BID ADDENDUM NO.2

CHILLICOTHE ELEMENTARY SCHOOL ADDITION

Issue Date: October 7, 2022

Project: Chillicothe Elementary School Addition
Chillicothe, Missouri

A105a

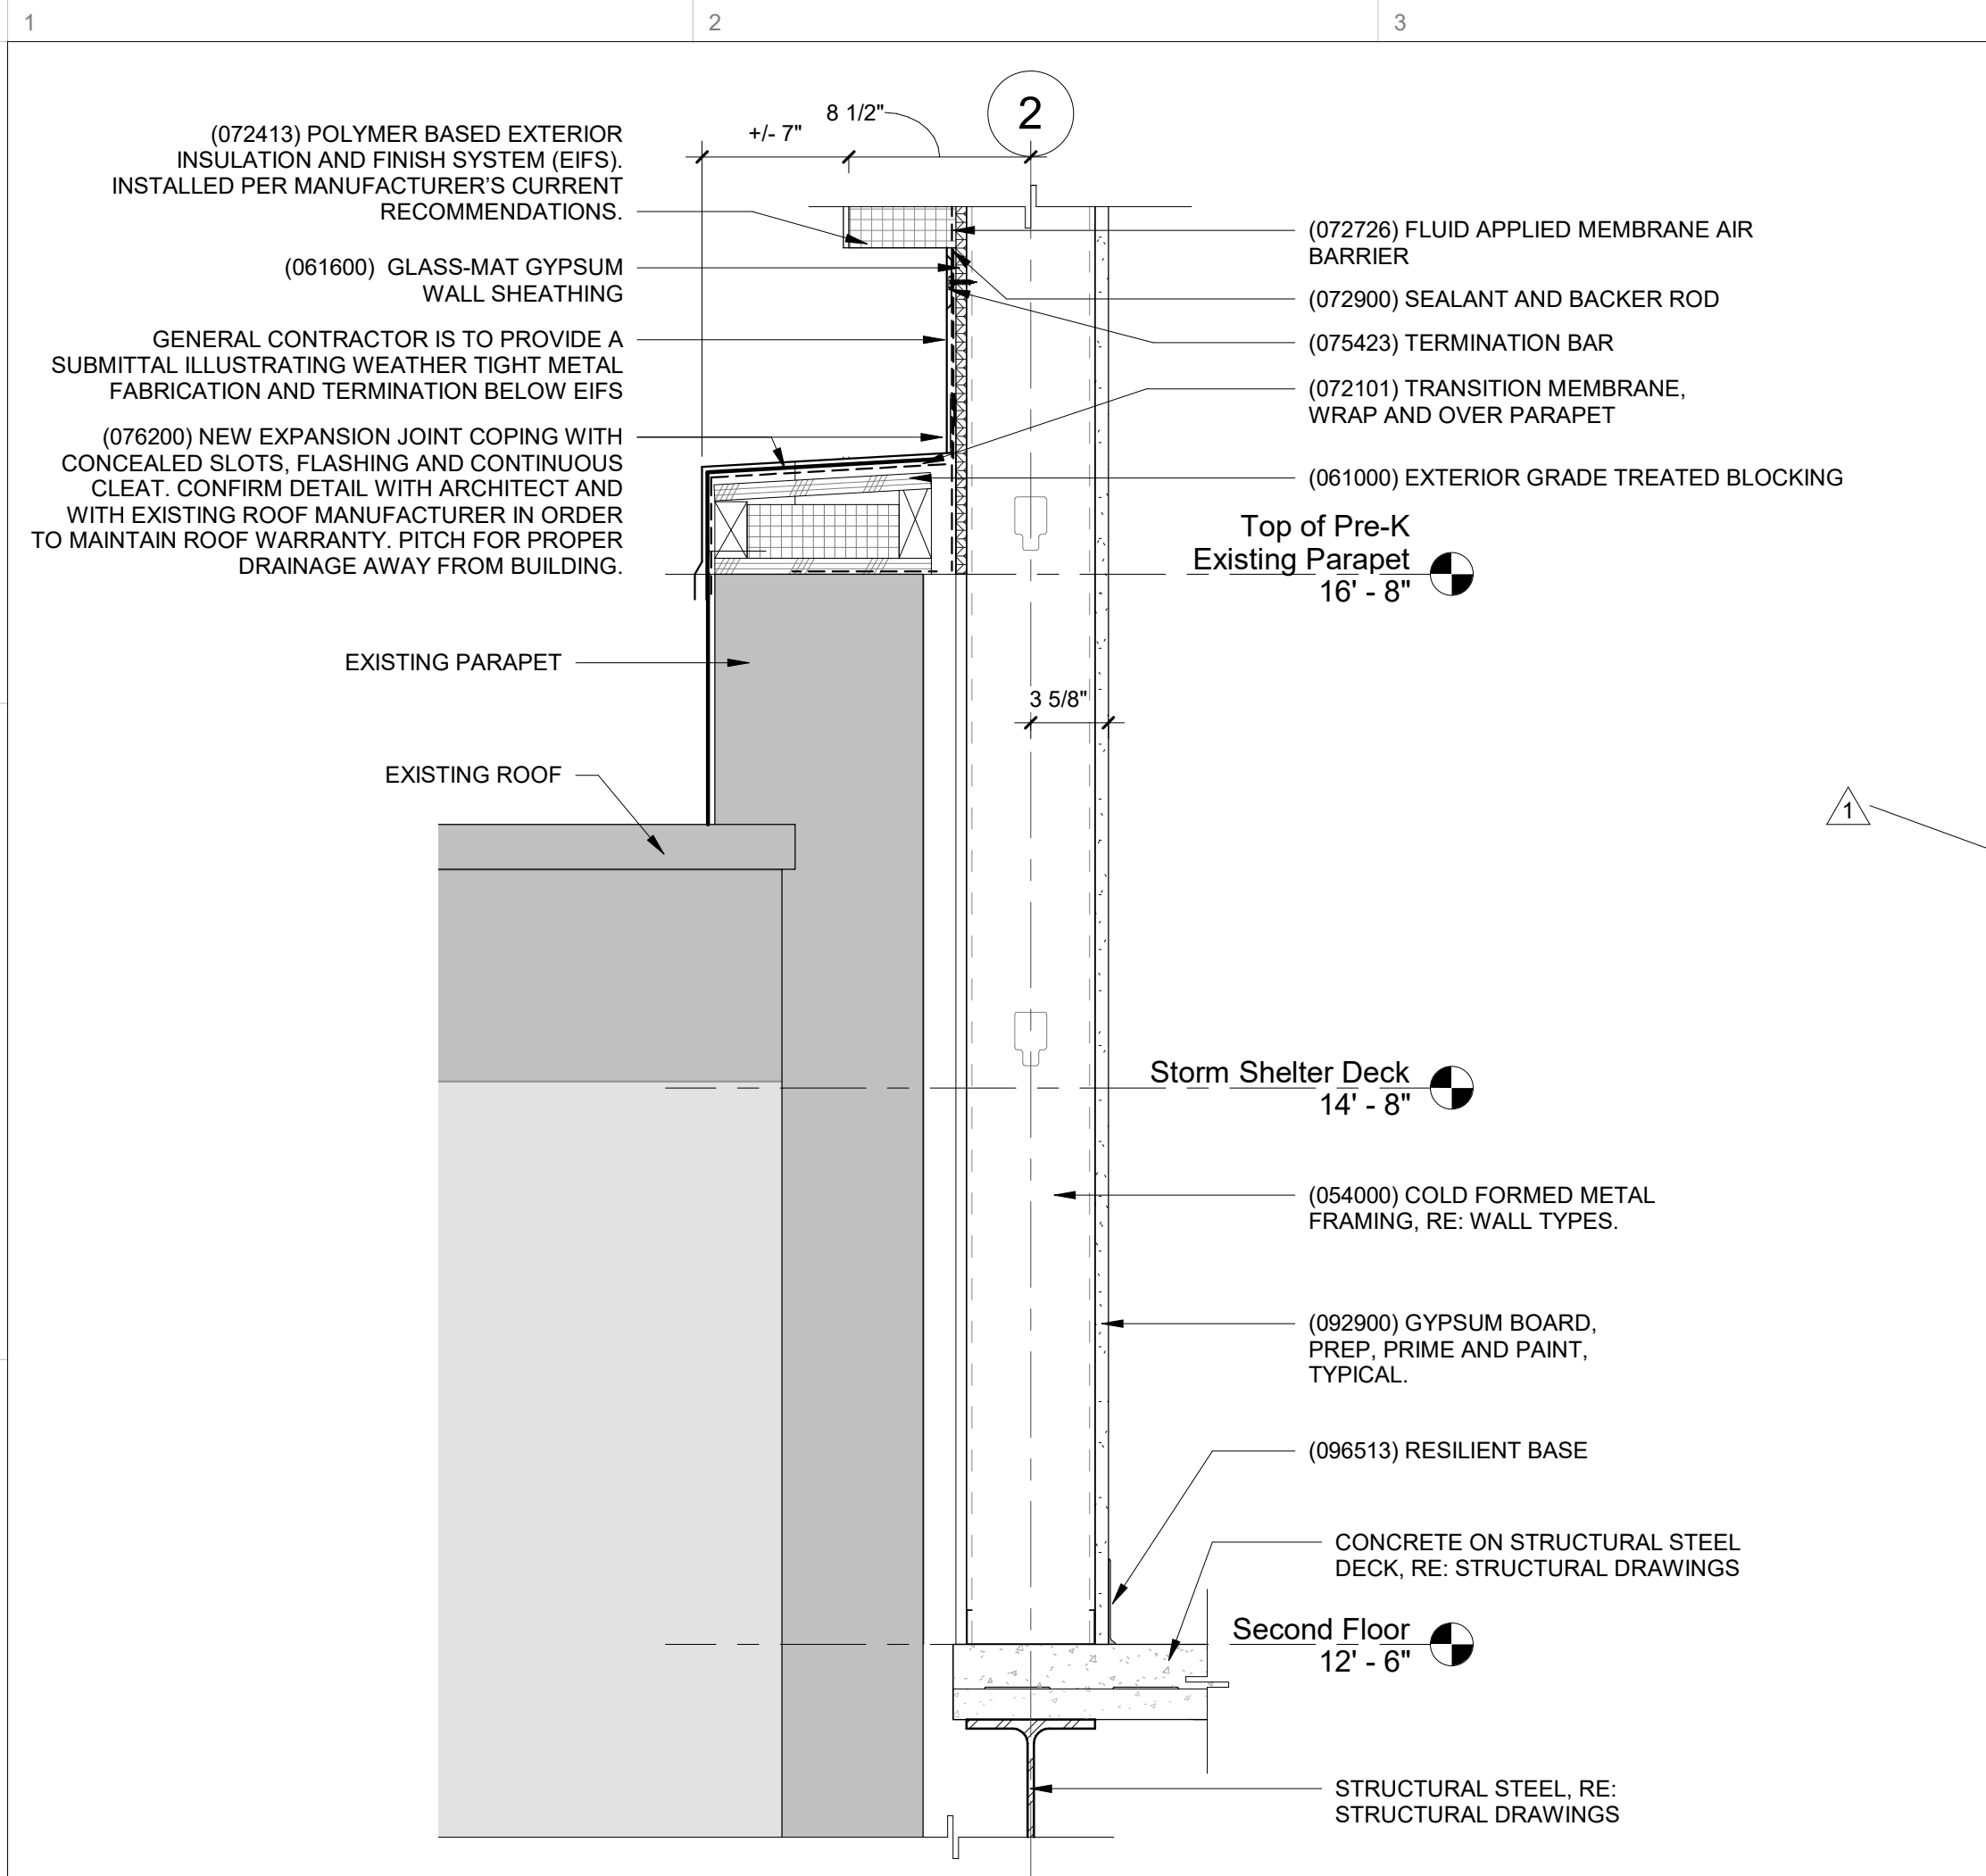
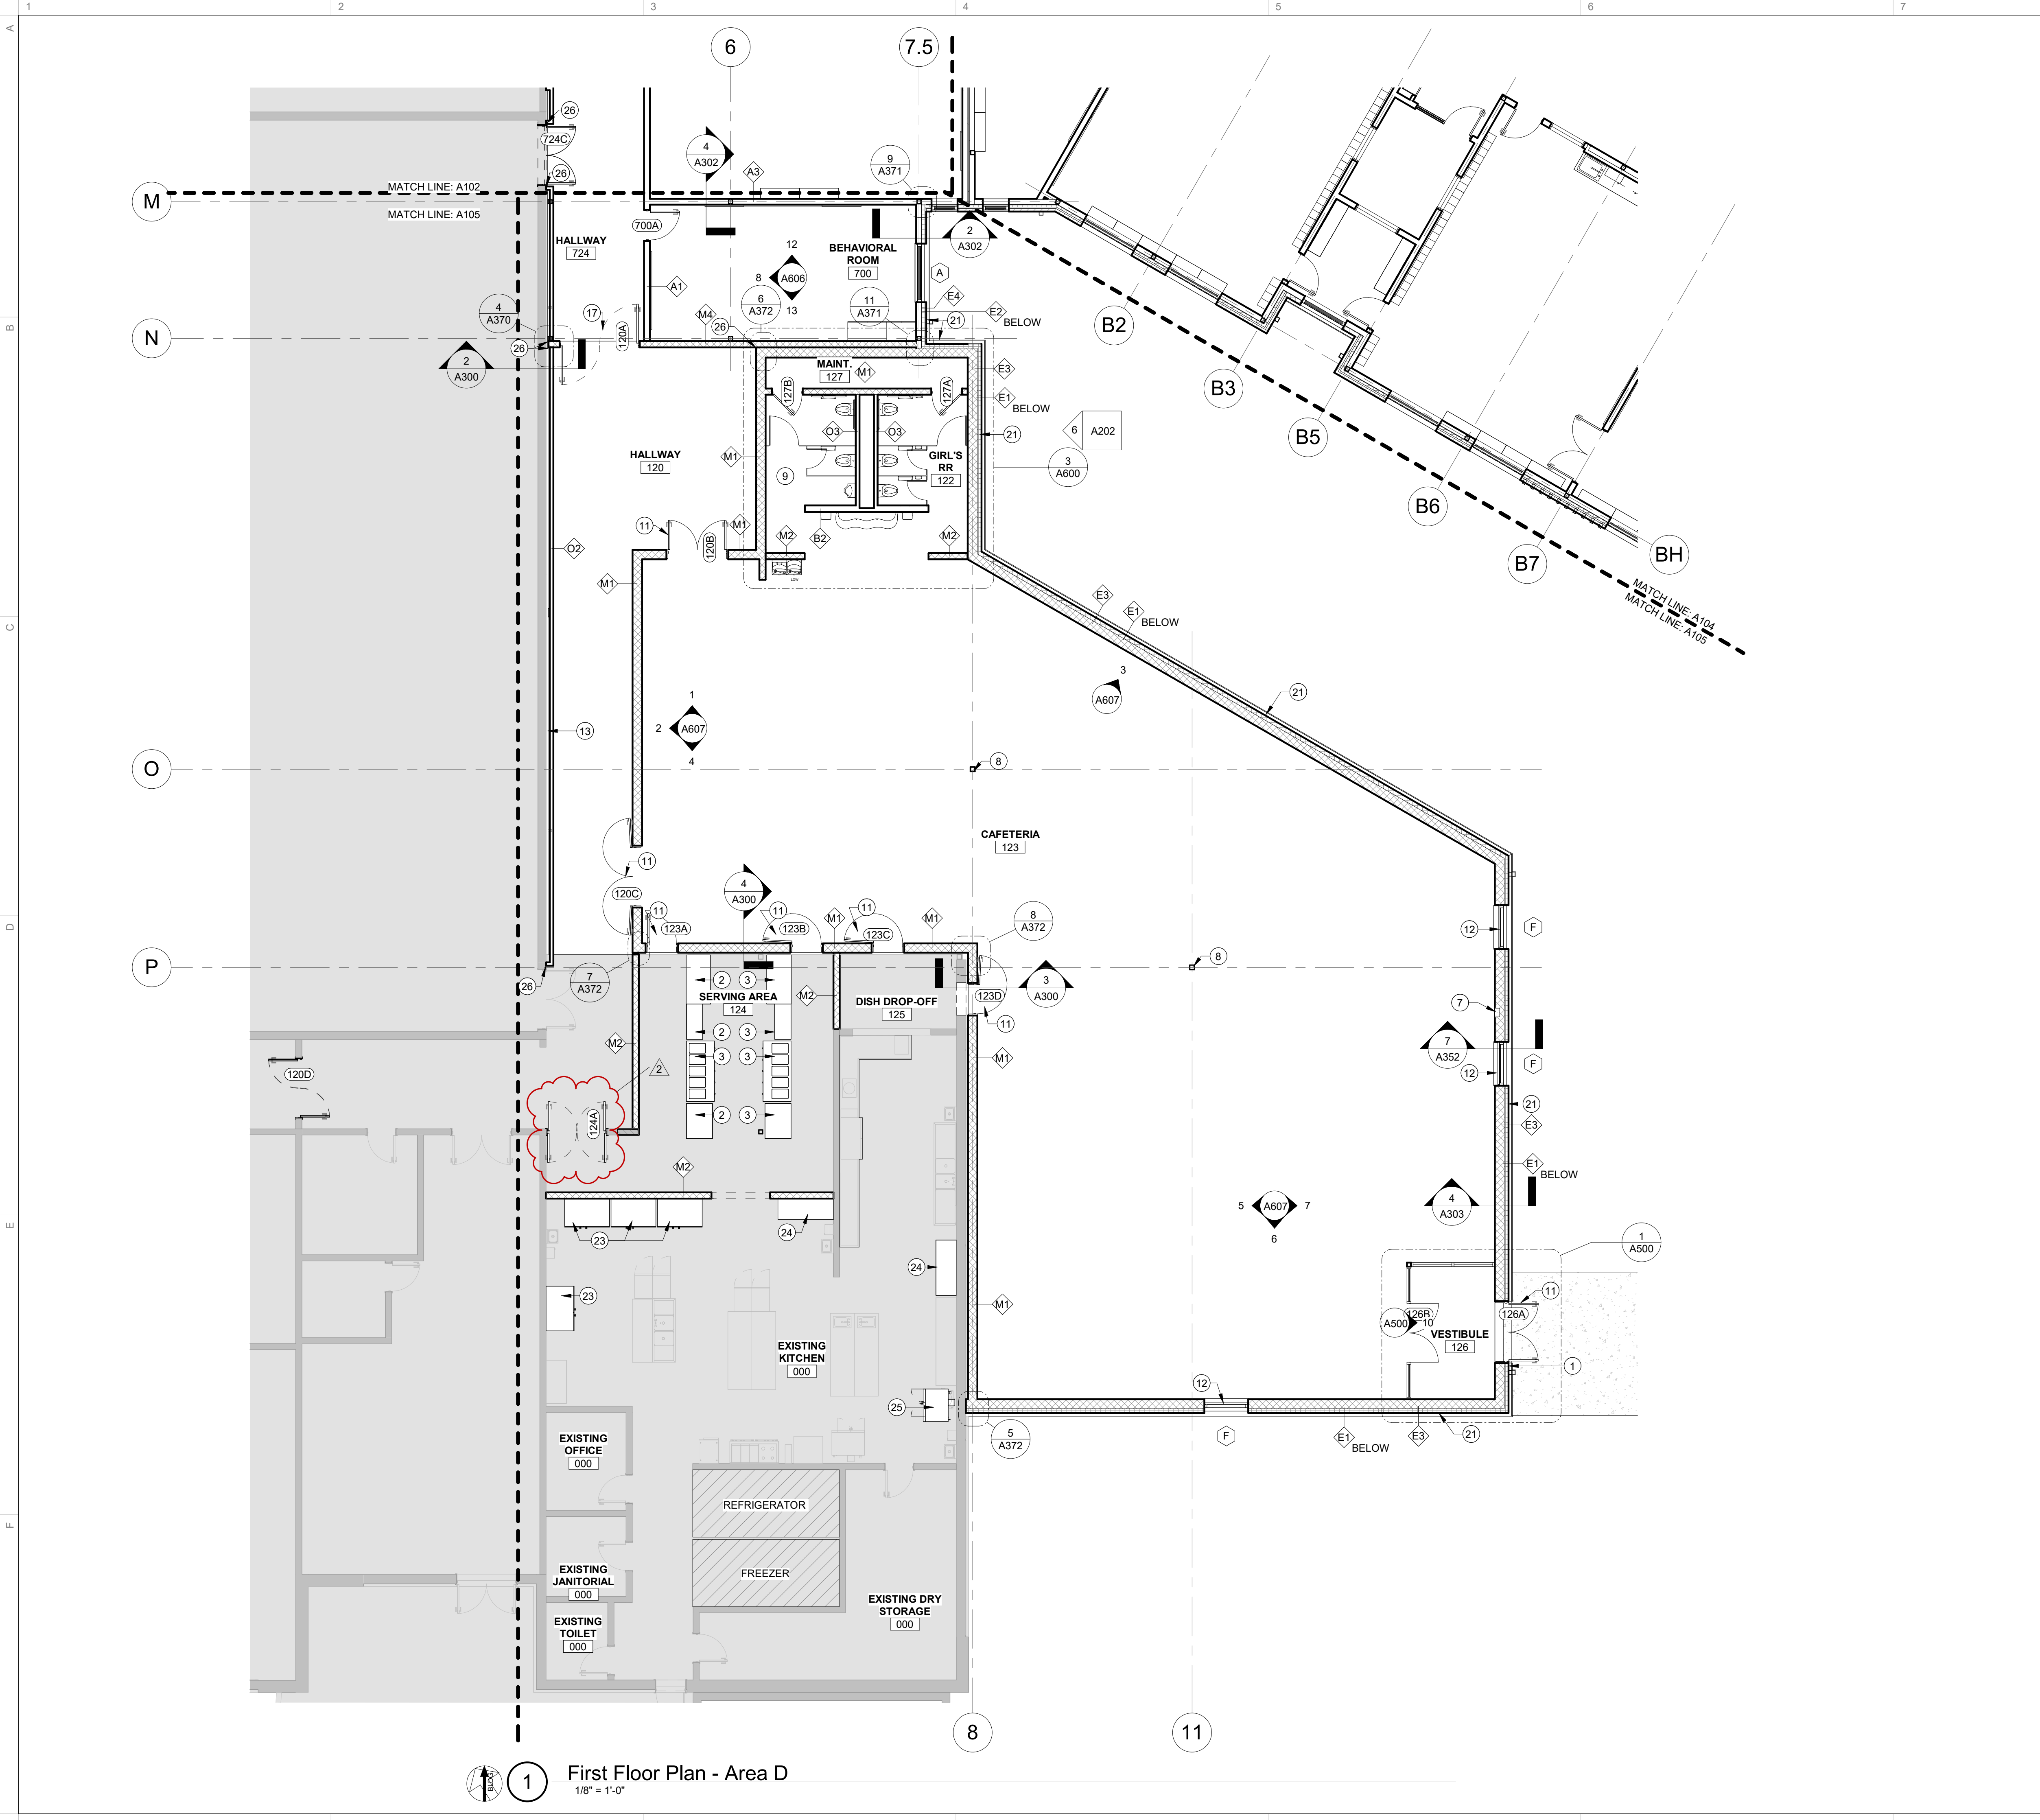
14. Question: 178a is indicated in the plans, but it's not on the door schedule nor in any hardware sets. Can you please let me know what size and type of door and frame and what hardware set it should belong to?

8. SHEET A105a:
 - a. MODIFY – On sheet A105a, door tag 178A was modified to read 124A.
9. SHEET A350:
 - a. MODIFY – Section 5/A350 to coordinate directions for heavy duty vapor barrier, waterstop, and dampproofing installation.

- a. Answer: On Sheet A105a, door tag 178A should read 124A. This door is included in the schedule and hardware. Reference sheet A105a issued in this Addendum.

5 Section Detail - CL 14 with New Roof
1 1/2" = 1'-0"

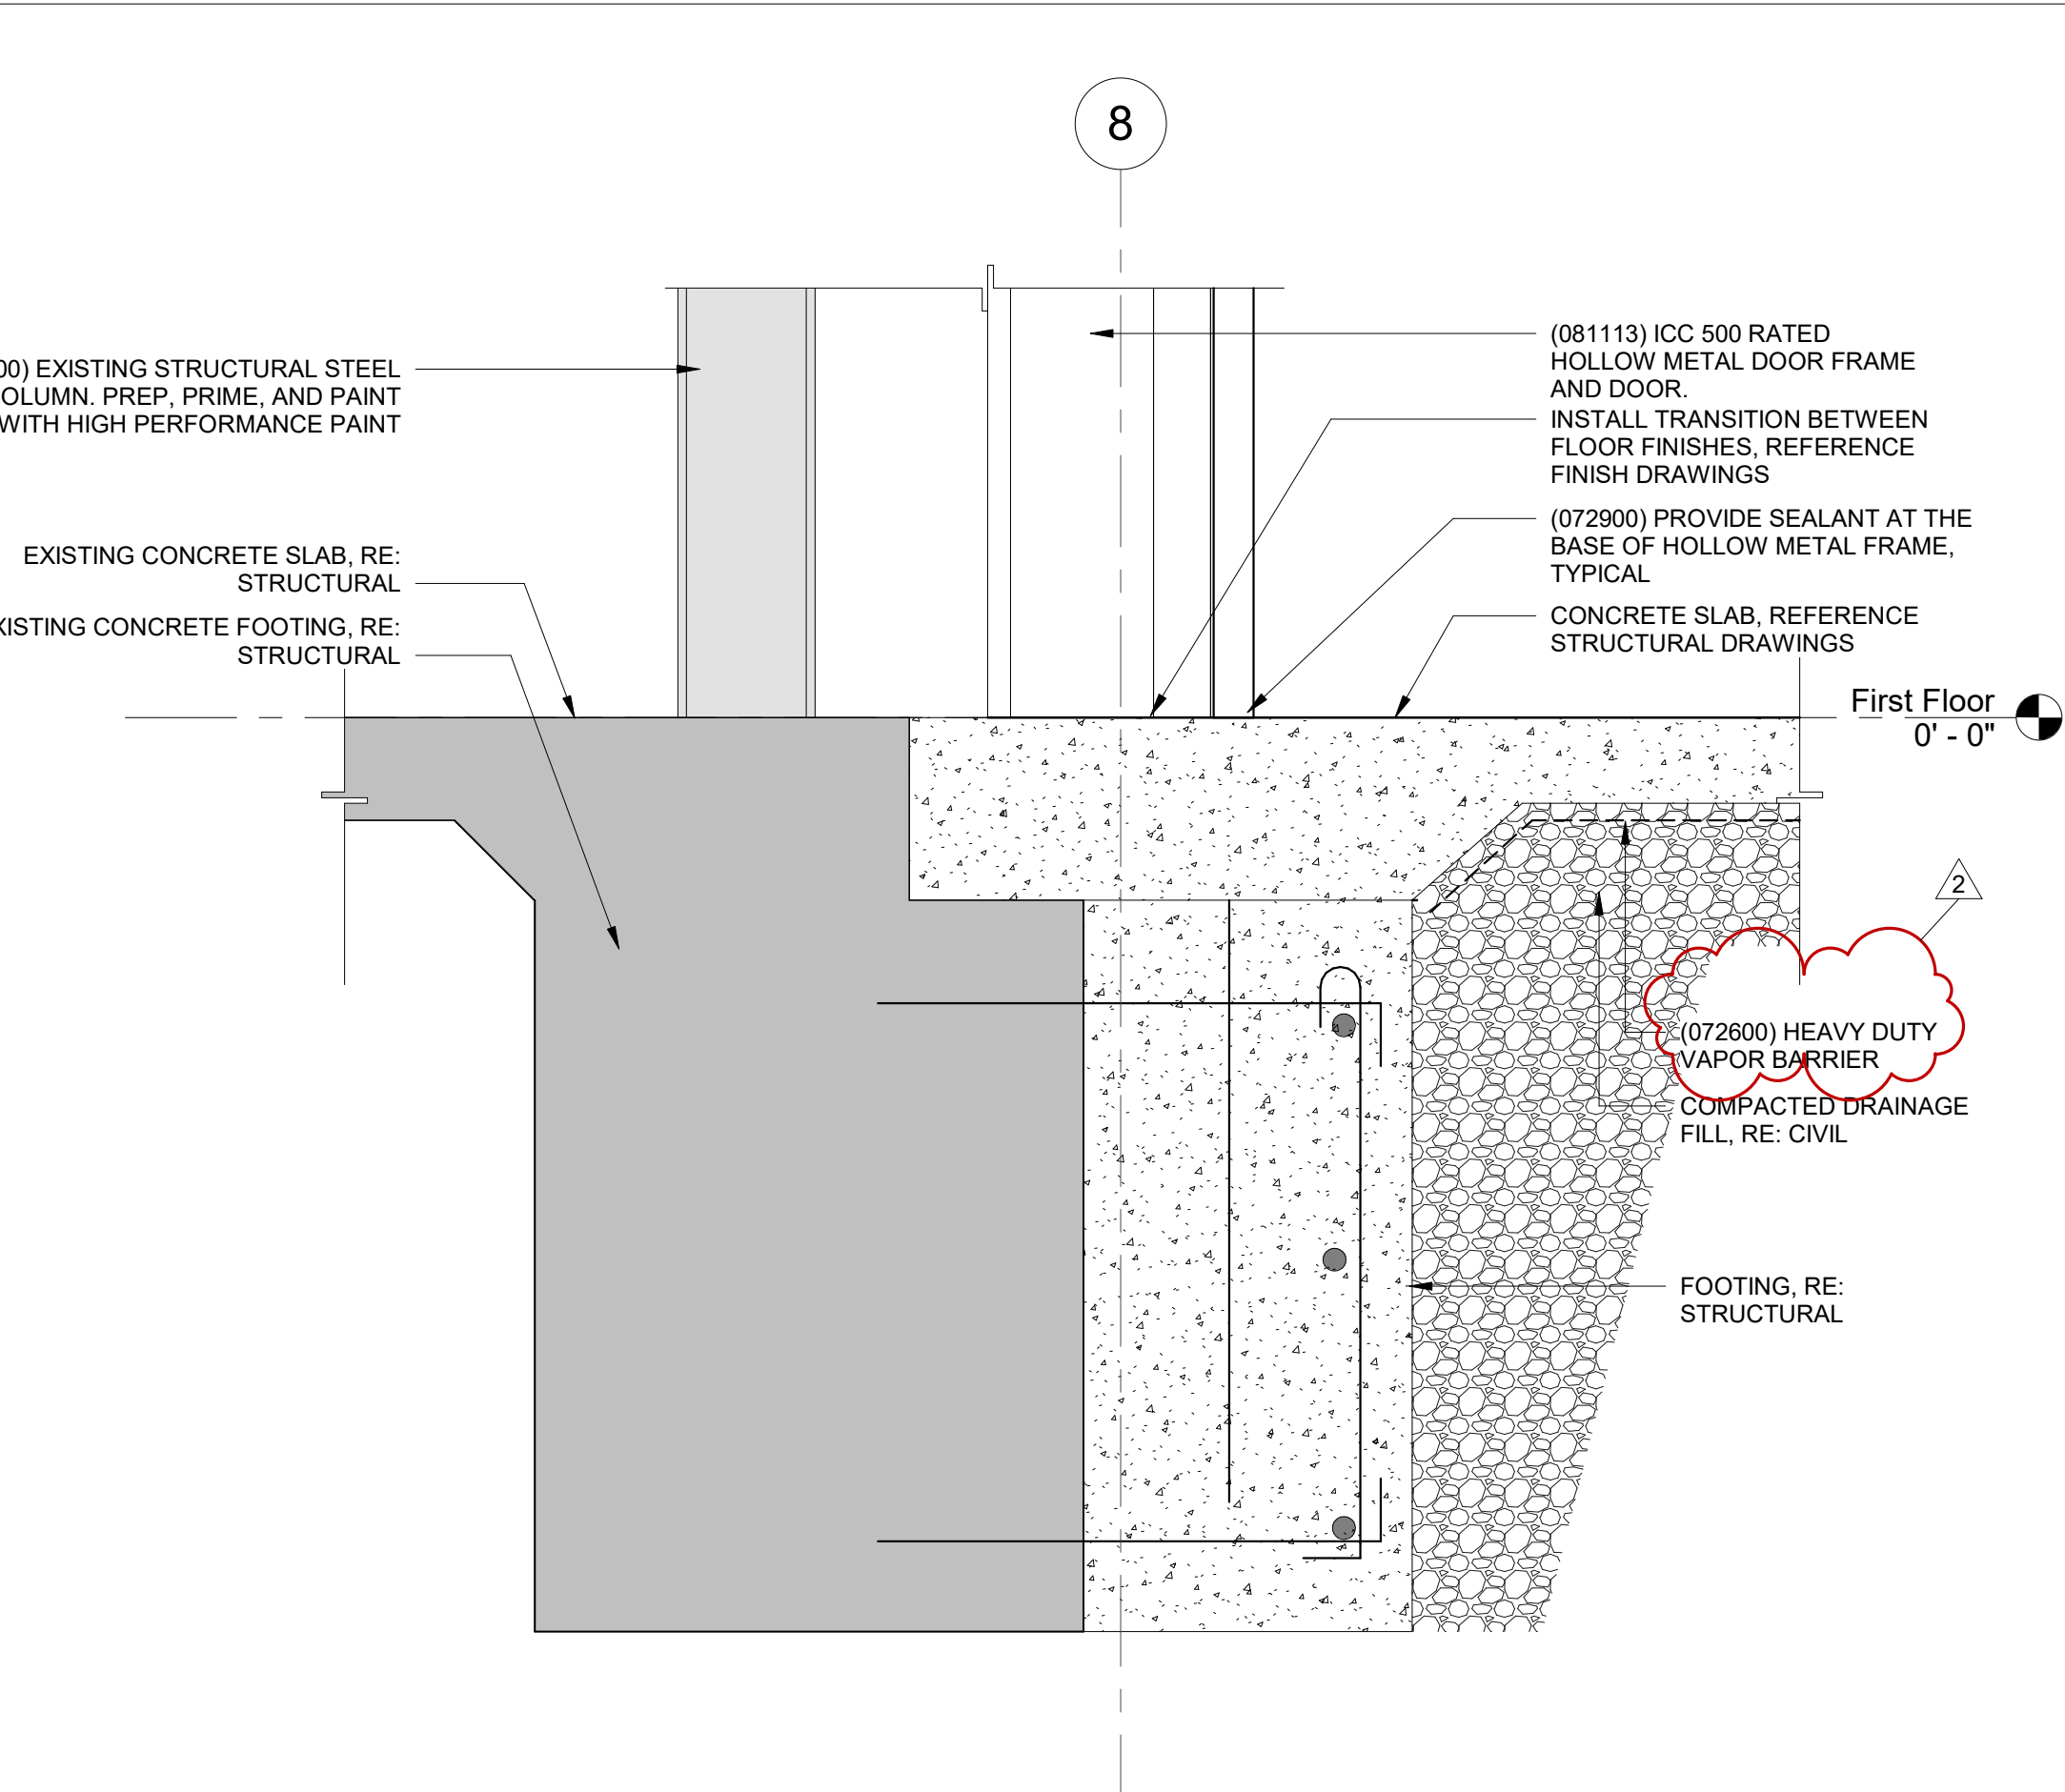
9. Question: Where should the waterstop be installed at exterior grade beams and foundation footings?
 - a. Answer: Reference sheets A350, A351, and A352 issued in Addendum #2. Dampproofing should be installed on the exterior vertical face of the first floor slab and the horizontal exterior face of the grade beams and foundation footings. A waterstop should be placed 4" in from the outside edge of the slab turndown. This is typical for all outside wall locations on the first floor.
